## Product / Process Change Notification (PCN)

**PCN Number:** PCN\_IndMAPI\_20241113

**Affected Series:** WE-MAPI

**Typical Temperature Rise vs. Current Characteristics**

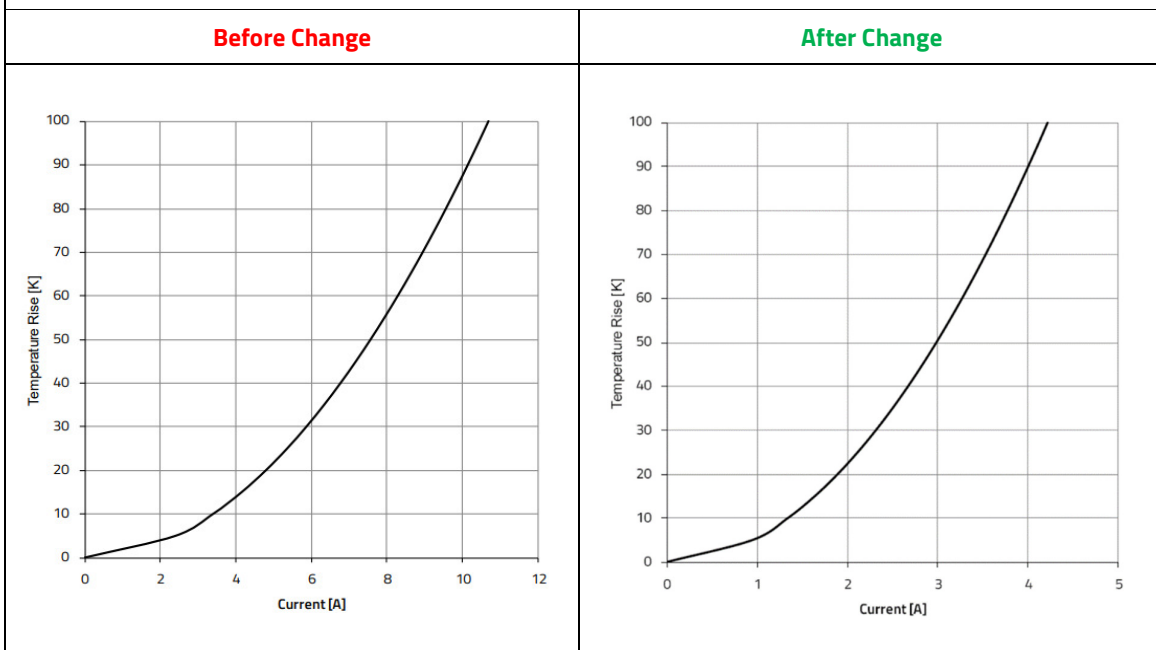
Affected Order Code: 74438324015HT

Performance Rated Current ( $I_{RP,40} / \Delta T = 40 \text{ K}$ )	
Before Change	After Change
4.7 A (max.)	2.9 A (max.)

Typical Temperature Rise vs. Current Characteristics

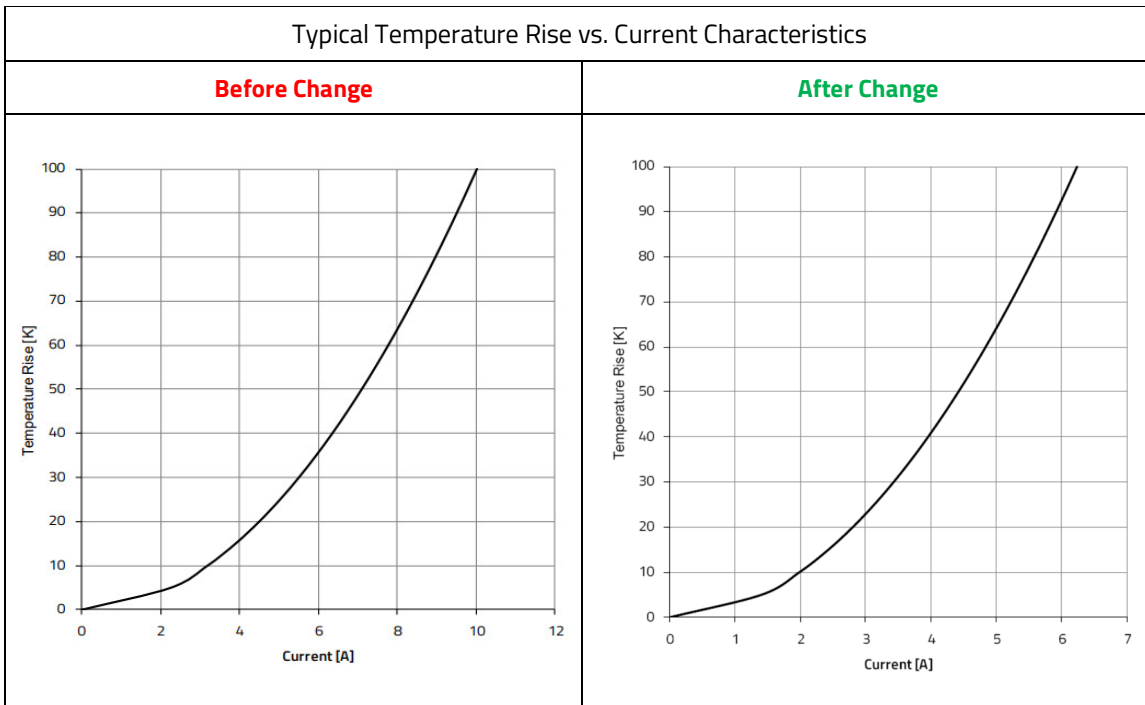
Affected Order Code: 74438335033HT

Performance Rated Current ( $I_{RP,40} / \Delta T = 40 \text{ K}$ )

Before Change	After Change
6.8 A (max.)	2.7 A (max.)
